EL MONTE UNION HIGH SCHOOL DISTRICT

April 26, 2023

TO : All Bidders
FROM : El Monte Union High School District
BID # : 2022-23(B8)
PROJECT : Mountain View HS Modernization Project
SUBJECT : Addendum No. 6

1. LPA Architects Addendum No. C issued April 26, 2023 attached.

DOOR TYPES

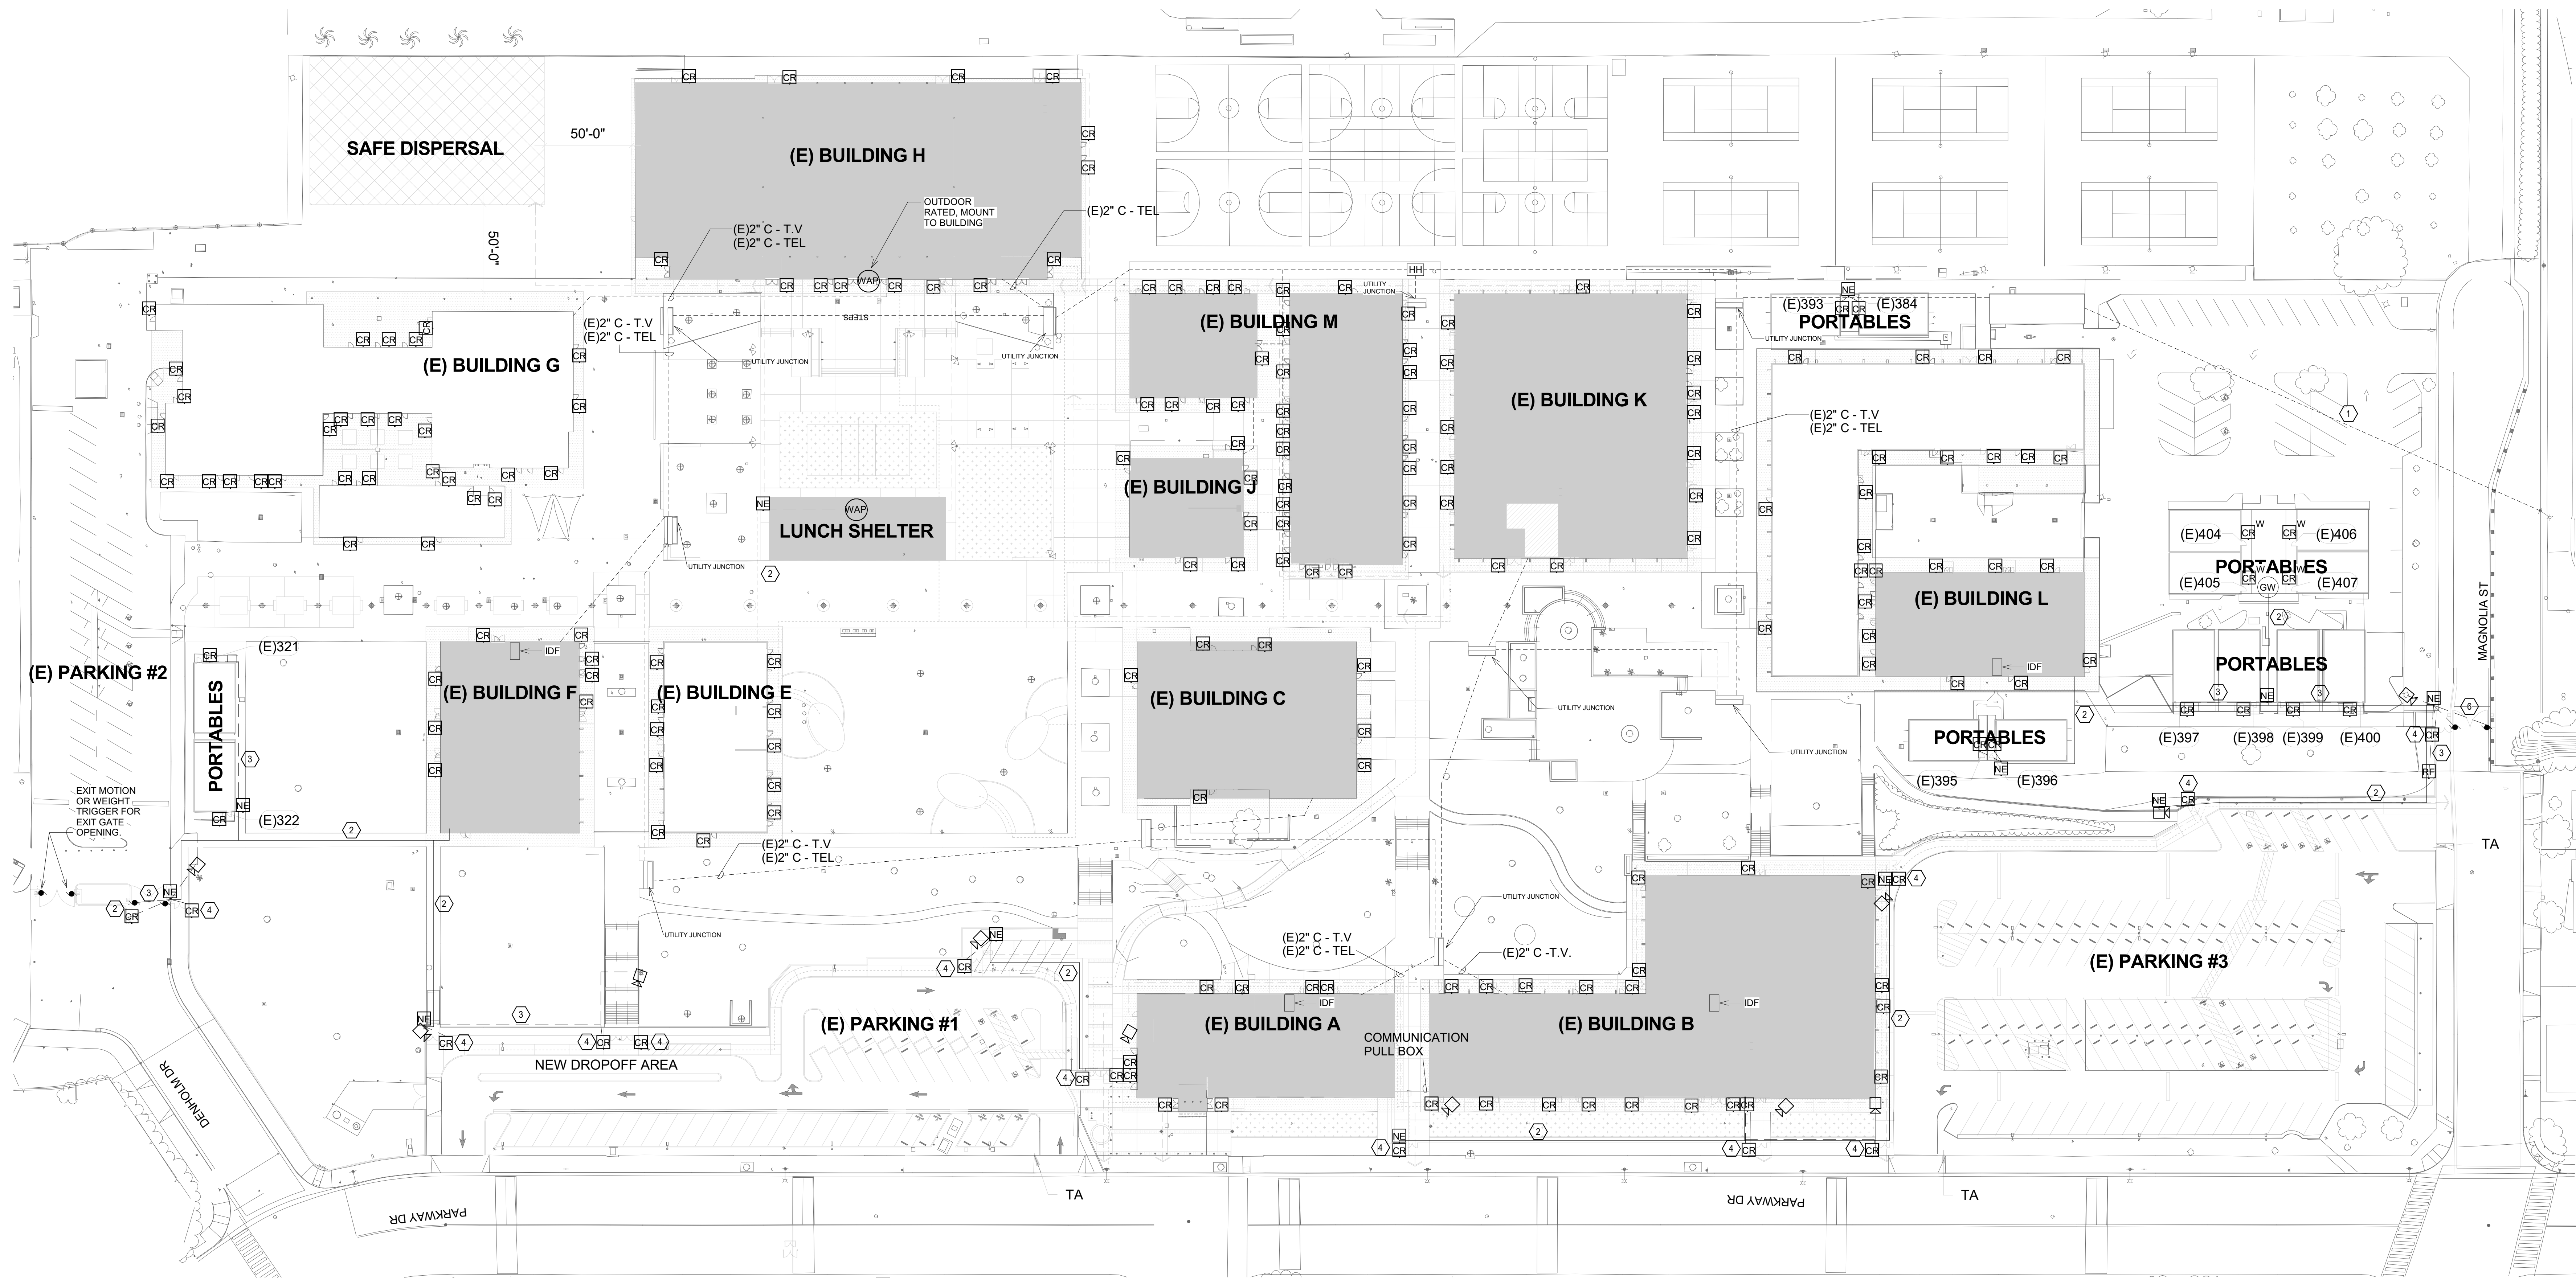
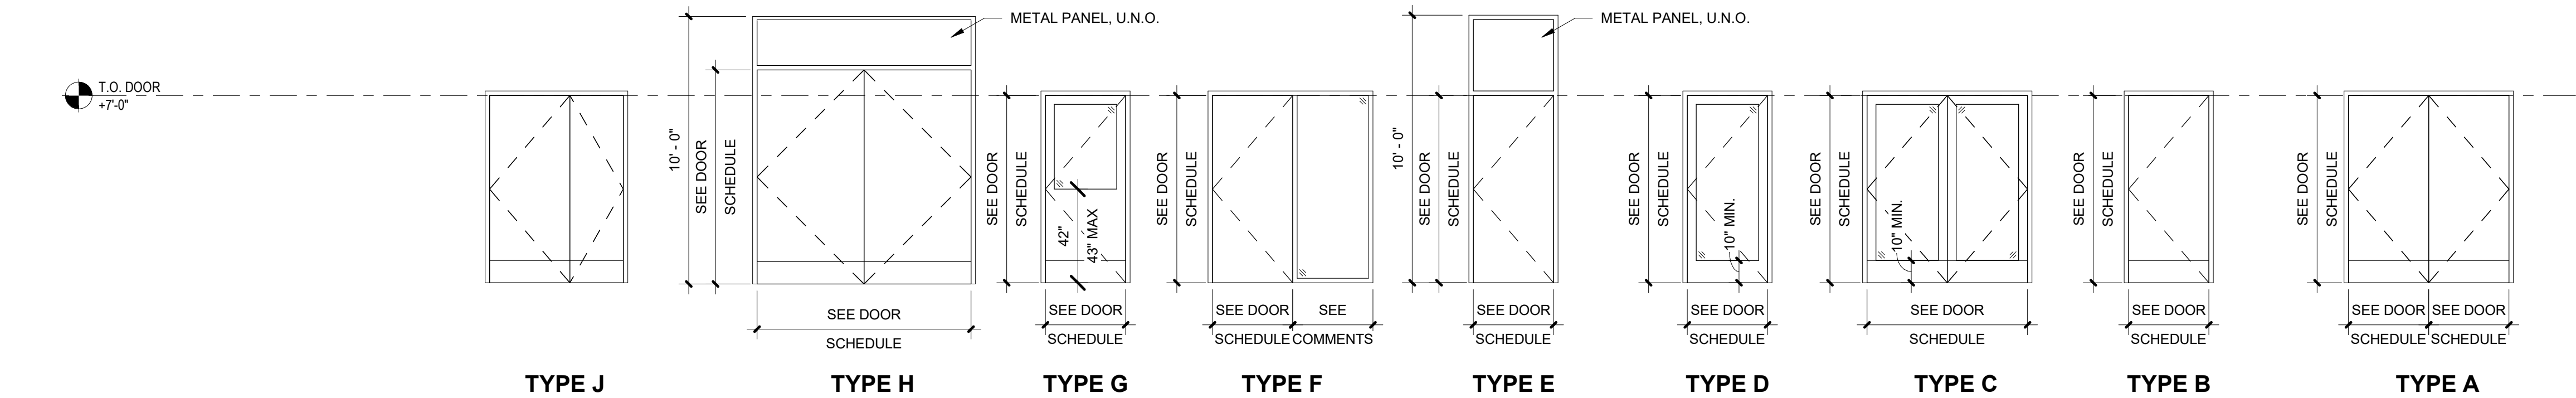
Item No. 20 **Sheet A6.01 – Door Schedule**
Updated door schedule per revised door hardware sets.

Item No. 21 **Sheet A6.02 – Door Schedule**
Updated door schedule per revised door hardware sets.
